VIRGIN ISLANDS WATER & POWER AUTHORITY

PR-05-24

St. Croix, Queen Mary Highway, St. Croix

ADDENDUM III

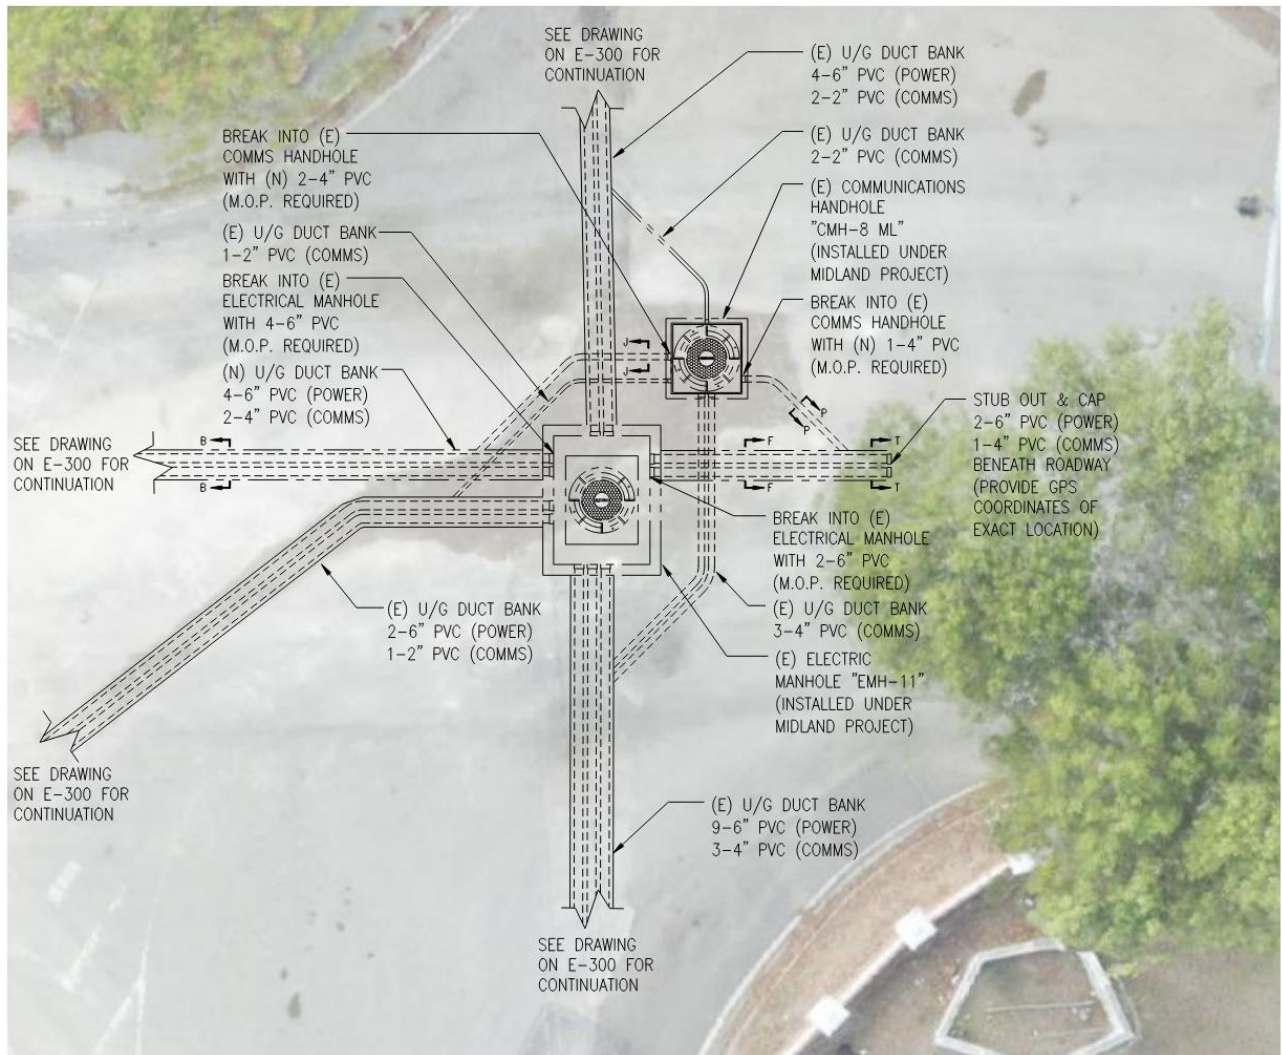
There is no duct bank section for trench types AA-AA and Z-Z.

Bid Form Line Items 7-Z and 7-AA will not have duct bank sections on the drawings. See Addendum I Bid Form for duct bank descriptions and lengths.

ENLARGED DUCT BANK PLAN (@ MIDLAND EMH-11)

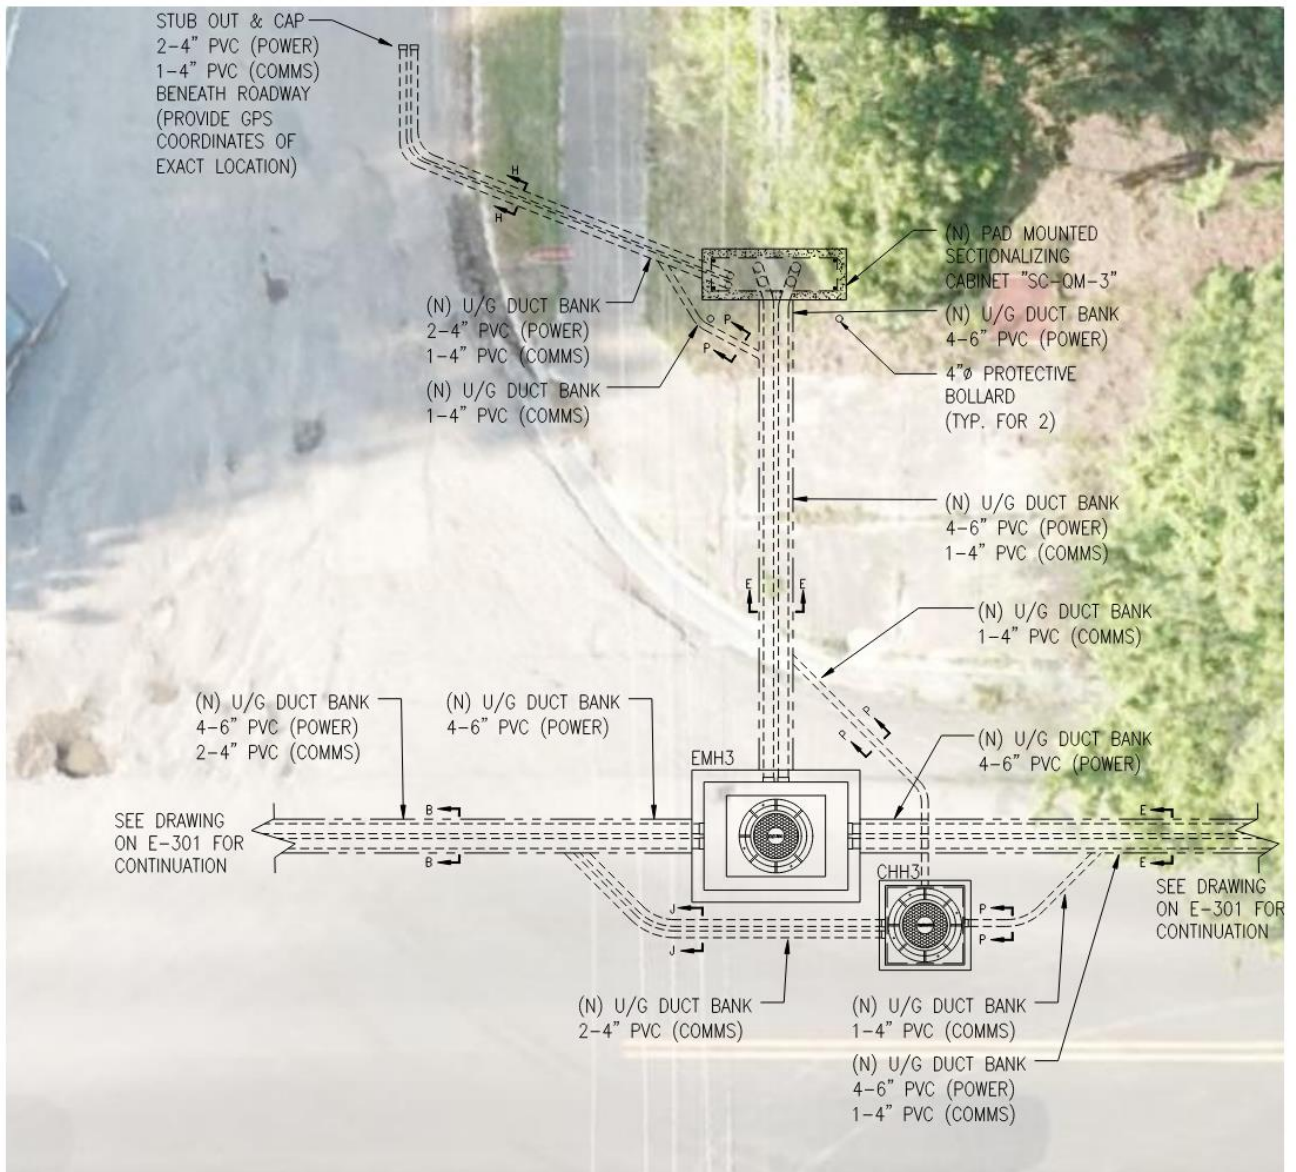
There are several locations where there are unidentified Duct Banks stemming from Manholes and Handholes. Please provide enlarged details for the following structures:

- (E) CMH-8 – STA. 0+00
- (N) EMH-3 & (N) CHH-3 – STA. 20+00-20+27
- (N) EMH-4 & (N) CHH-4 – STA. 31+75-32+00
- (N) EMH-5& (N) CHH-5 – STA. 40+11-40+46

In response to this request please refer to the following (5) enlarged plans. These enlarged plans will be included in the 'Issue for Construction' set of drawings, which will be released after the contract is awarded.
